**TOWN OF MOUNTAIN VILLAGE  
REGULAR DESIGN REVIEW BOARD MEETING  
THURSDAY DECEMBER 5, 2019 10:00 AM  
2nd FLOOR CONFERENCE ROOM, MOUNTAIN VILLAGE TOWN HALL  
455 MOUNTAIN VILLAGE BLVD, MOUNTAIN VILLAGE, COLORADO  
AGENDA**

**Agenda Item No. 6  
PLANNING AND DEVELOPMENT SERVICES  
DEPARTMENT**

**Case Summary:** Chris Hawkins of Alpine Planning and Tommy Hein of Tommy Hein Architects, acting on behalf of O’Dea Development Services, INC., are requesting Design Review Board (DRB) Initial Architectural and Site Review approval of a new single-family home located at 102 Granite Ridge, Lot 137. The applicants have submitted all required materials in accordance with the provisions of Section 17.4.6 of the Community Development Code (CDC) for a Class 3 Initial Review.

DRAFT SITE PLAN	19.09.30
CLIENT REVIEW	19.10.29
DRB 1 SKETCH v1	19.11.11
DRB 1 SKETCH v2	19.11.13
DRB 1 SKETCH v3	19.11.14
OWNER   CONSULTANTS	19.11.14
DRB 1 SKETCH v4	19.11.20

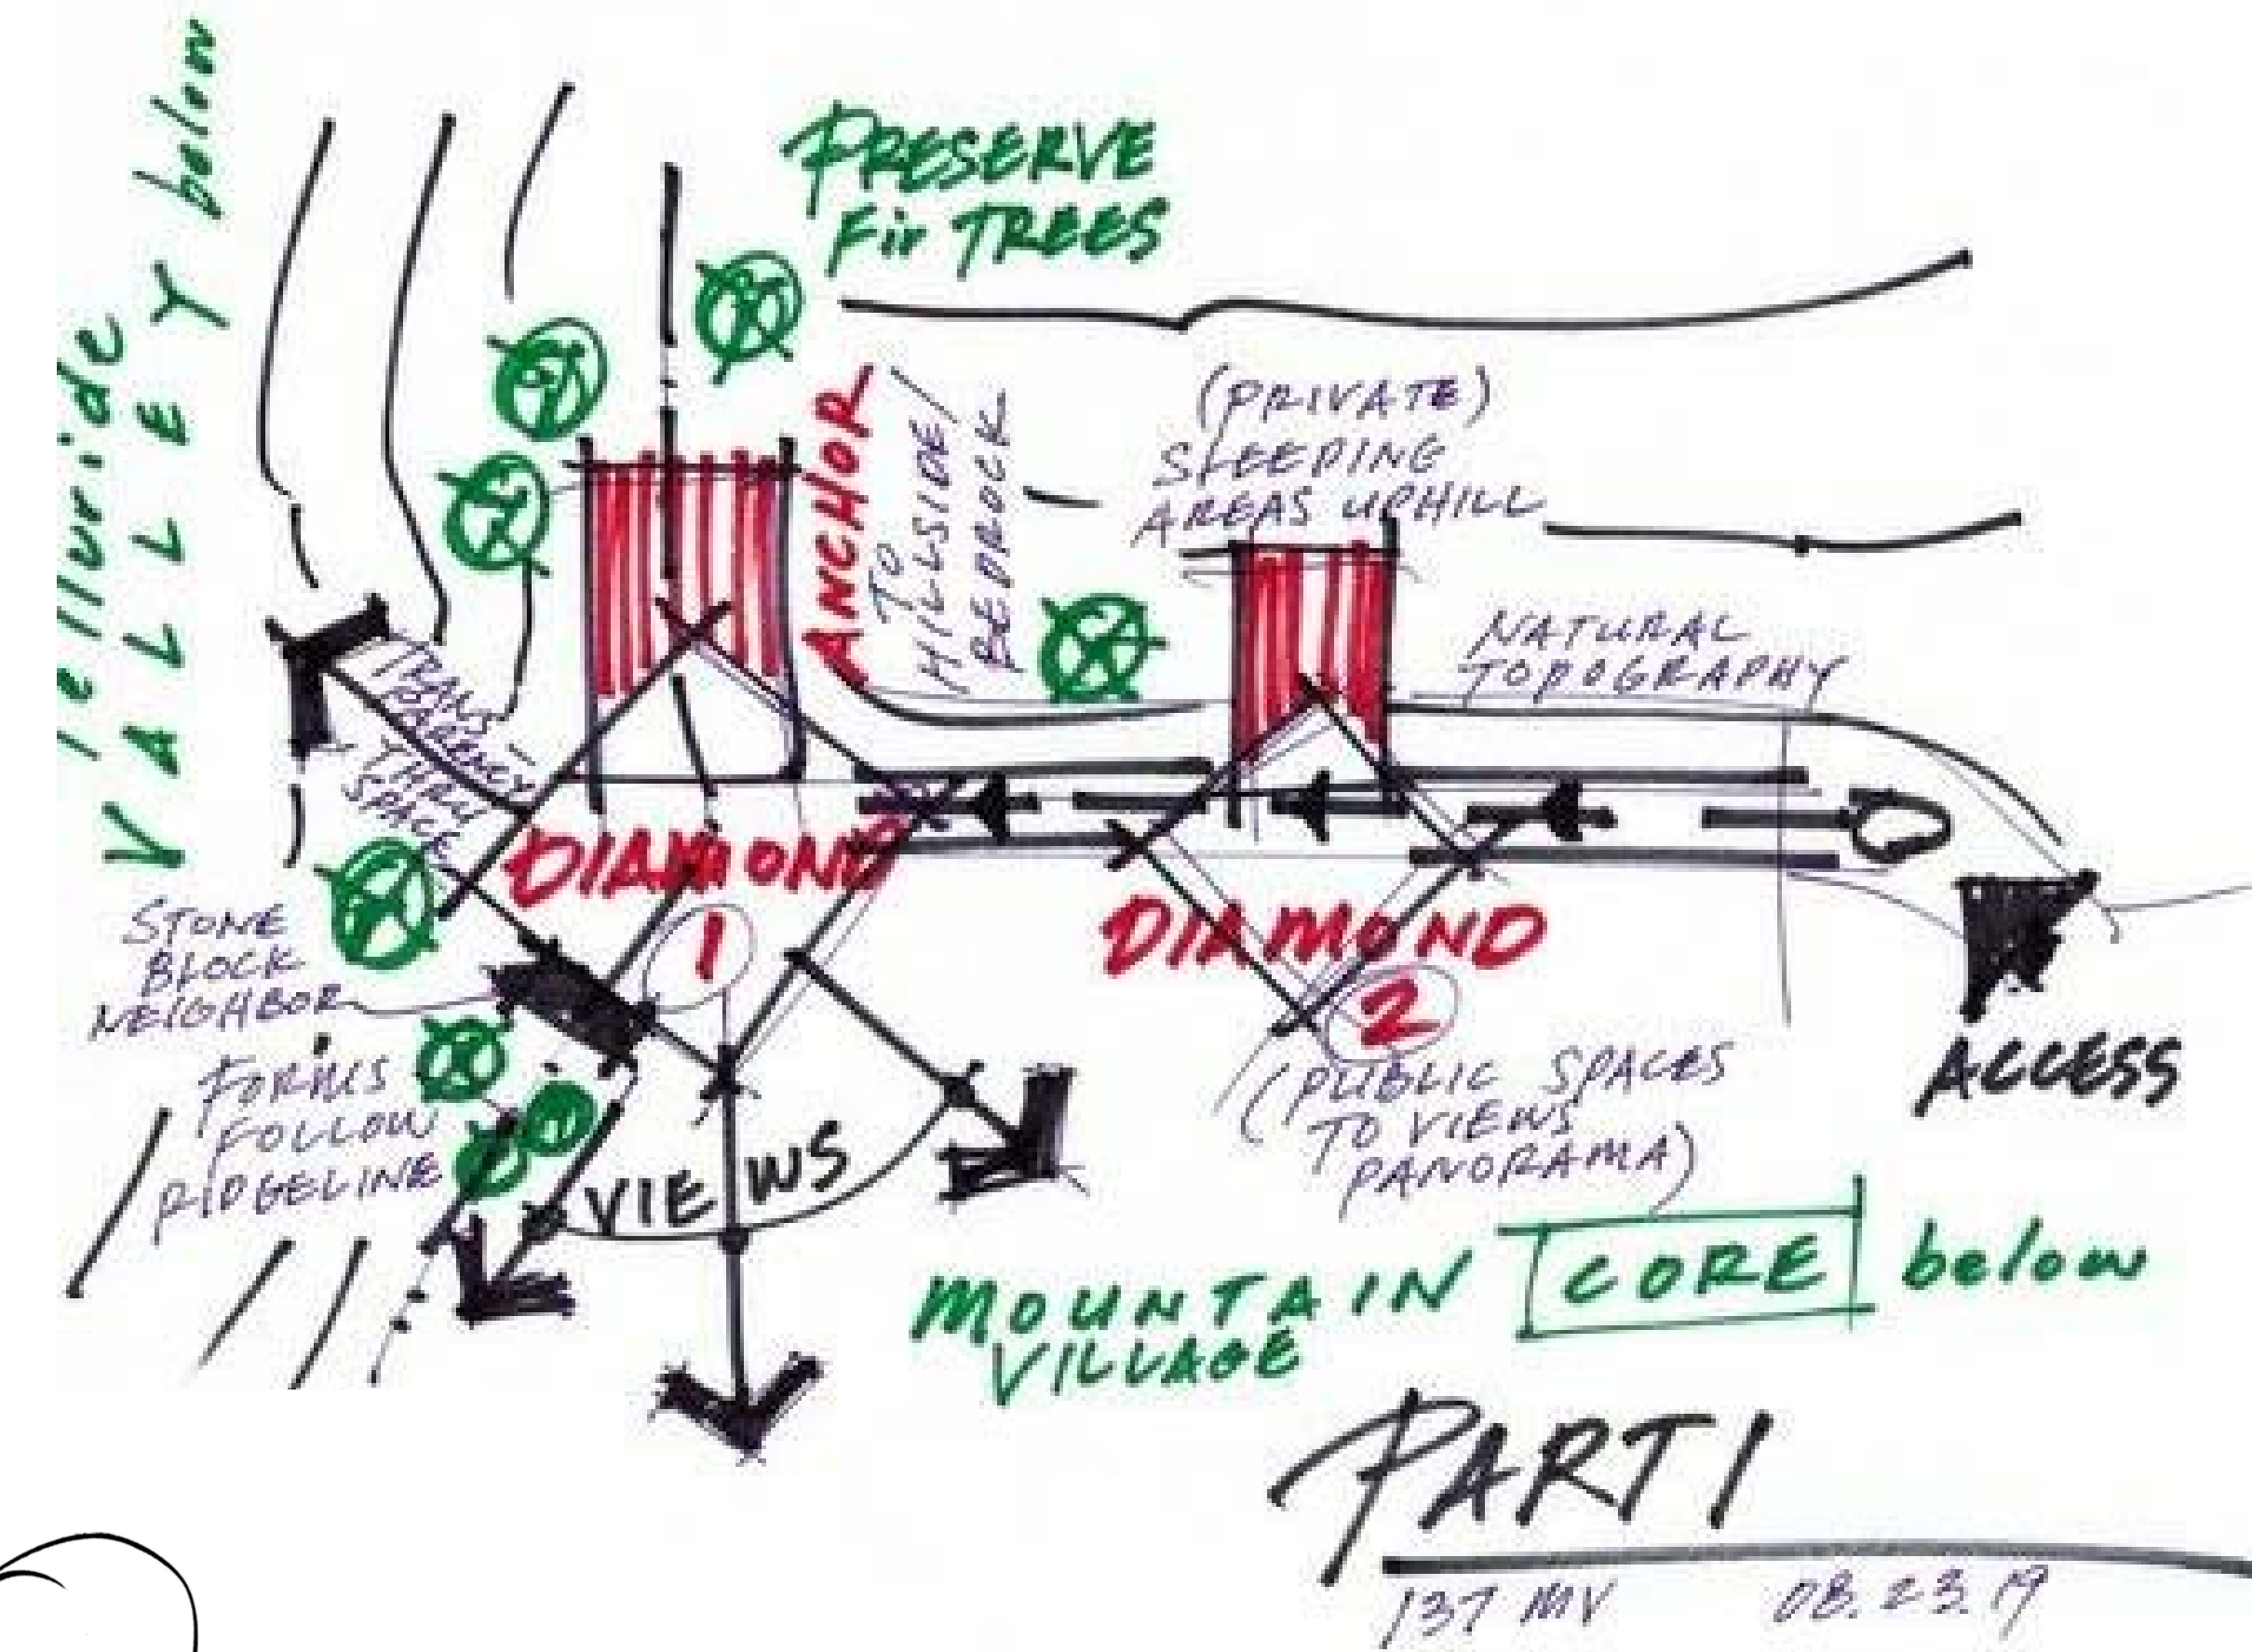
*Ski Access: Sheet A1.0 of the submitted plans show a ski in – ski out access that is generally located within the driveway area. It's unclear to staff at this time as to how the applicants propose to traverse from Lot 137 to the ski resort as there are no contiguous parcels owned by TSG between the lot and the resort. If this is determined to be unrealistic, then the applicants will need to revise plans and remove references to ski access prior to final review. Otherwise, the applicants will need to provide written documentation from TSG permitting access from the site to the resort.*

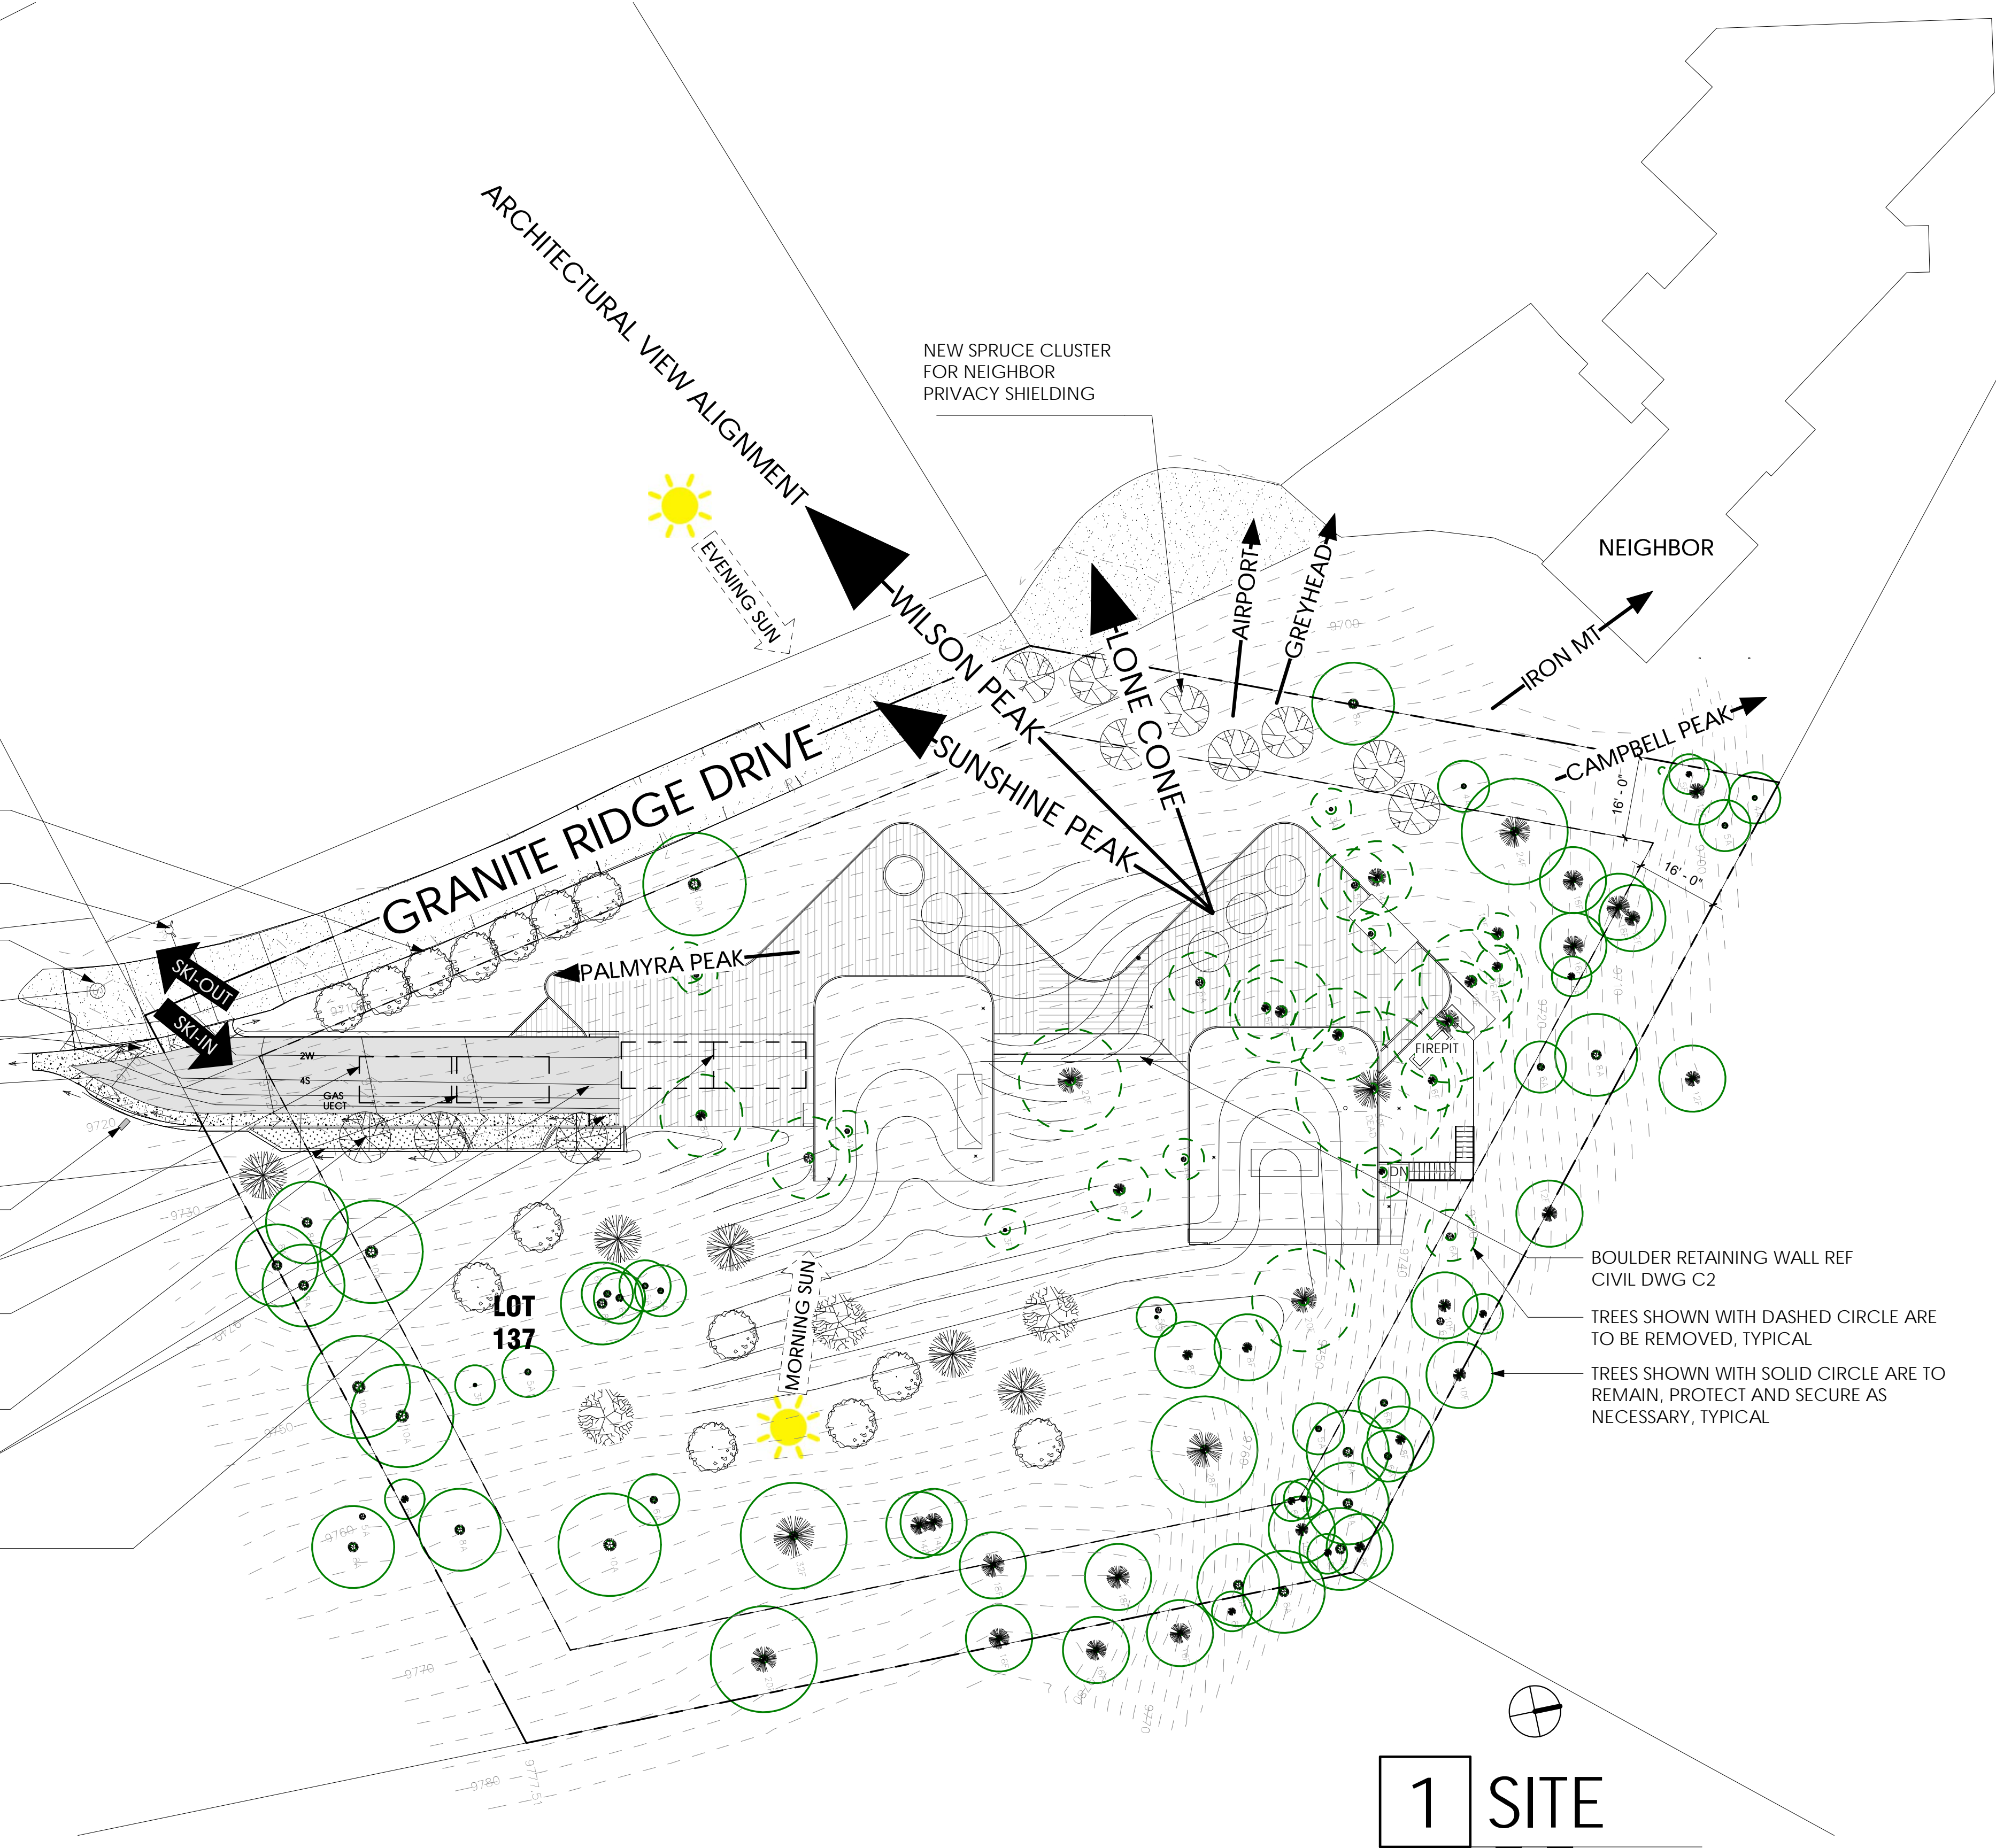
*The CDC requires all single-family developments provide 2 enclosed spaces and two exterior spaces. The applicants have proposed 2 enclosed parking spaces and 2 exterior spaces, yet as shown the spaces are all tandem (double-parked) and it would be difficult to utilize all of the parking as shown in a practical manner. Staff does not agree that the proposed parking design as shown is meeting the intent of the CDC and the DRB will need*

*to determine if the parking as shown is adequate or if the plans will need to be modified prior to final review. Per the CDC there is a provision for allowing two tandem spaces on lots less than .75 acres when non-tandem is not feasible due to unique site conditions. However, this lot is greater than .75 acres and staff recommends the impractical parking configuration be addressed in a more meaningful manner. Otherwise, the review authority needs to specifically approve tandem parking (garage or surface) on this property.*
